Name	Company	Email
<b>To</b>	Jamel Sadiki	Built	<a href="mailto:jamelsadiki@built.com.au">jamelsadiki@built.com.au</a>
<b>Date</b>	01/03/2023	<b>Job no</b>	SY210113
		<b>CA no.</b>	6.1
<b>Project</b>	Lands Building – 23 Bridge Street, Sydney

This letter is provided in response to the below advice received from Heritage NSW in response to MOD 18 on 08/02/23.

**Figure 1 Corridor void linking into the fire compartment above via the framed floor-ceiling**

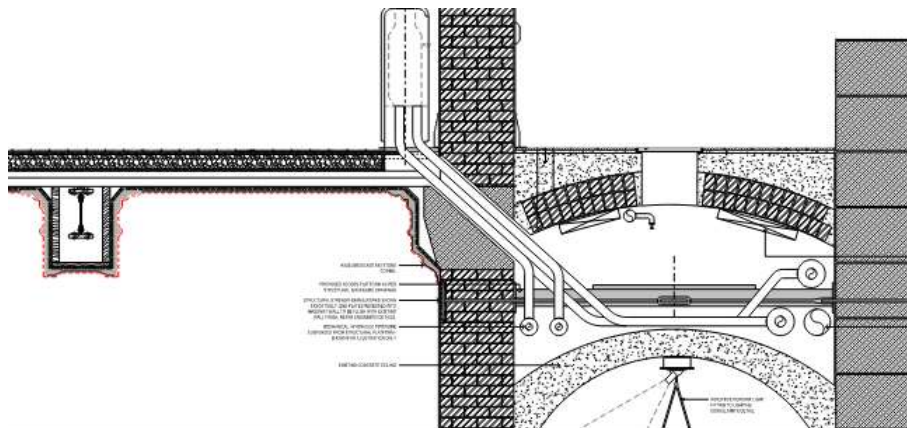
It is understood that the fire strategy for the Lands project has the corridor voids in the same fire compartment as the floor above – linking the corridor voids into the ceiling cavity as shown in Figure 1.

Due to this compartmentation definition, the floor-ceiling cavity and the top floor lining effectively become redundant, and the bottom ceiling lining – which in this case is timber lath and plaster – becomes the only fire separating element against vertical fire spread. I.e the FRL is now required to be measured on the top side of the timber lath and plaster ceiling – rather than on the top side of the floor lining. Consequently, instead of a typical floor-ceiling system incorporating a ceiling lining, a deep cavity, and a top lining, we now have just the ceiling lining required to achieve the full FRL performance with respect to integrity and insulation.

Unlike RISF, FRL is measured against more stringent (lower) temperature thresholds. FSH 1343 exhibited that with 700 microns of CAP coating, the temperatures on the top side of the 16-17 mm thick fibrous plasterboard exceeded 250 °C at 76 minutes. Thus, with a lower temperature threshold, the Lands ceilings (minimum 21mm thick timber lath and plaster), can only be expected to maintain insulation to achieve a 60 min FRL.

The above outlines the key variance between Lands and the CAP508 test arrangement and why the existing testing cannot be relied upon for a 90/90/90 system at Lands. Further fire testing was undertaken with CAP Coatings in an attempt to provide a 90/90/90 for Lands arrangement; however, following the failed pilot fire test 1a, it was decided that subsequent test was not necessary.

However, the fire test data obtained still provided a high degree of confidence in relation to the actual fire performance of the system, where it achieved a 60 min FRL for the Lands on-site arrangement.
